SUBJECT: ISSUANCE OF AMENDMENT NO. 27 TO FACILITY OPERATING LICENSE NO. NPF-29
TO IMPLEMENT TRANSFER OF AUTHORITY FOR CONTROL OF LICENSED ACTIVITIES,
AND EXEMPTION TO 10 CFR Part 100

RE: GRAND GULF NUCLEAR STATION, UNIT 1

Amendment No. 27
License No. NPF-29

Figure 6.2.1-1 Offsite Organization

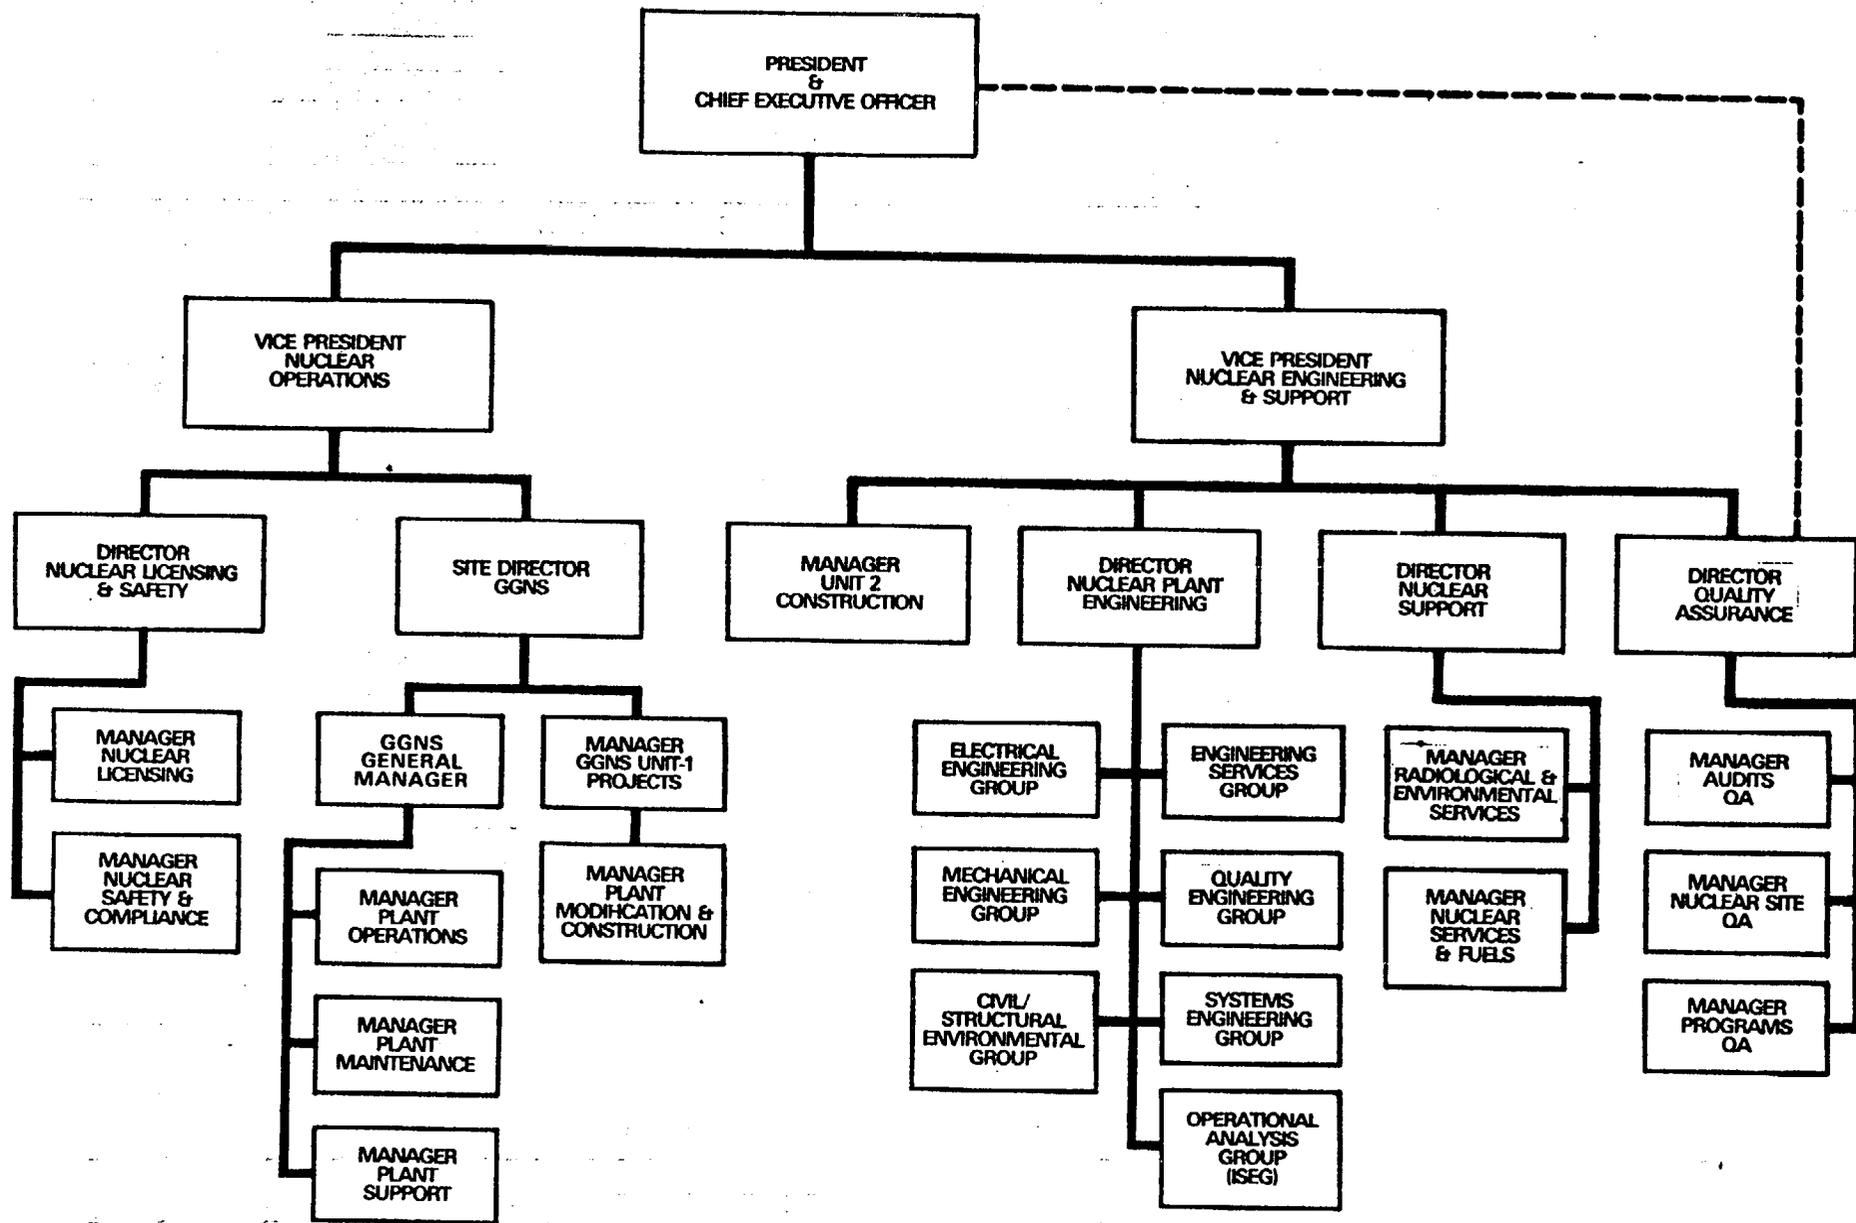
Replace the following pages of the Appendix "A" Technical Specifications and the Appendix B Environmental Protection Plan with the attached pages. The revised pages are identified by Amendment number and contain vertical lines indicating the area of change.
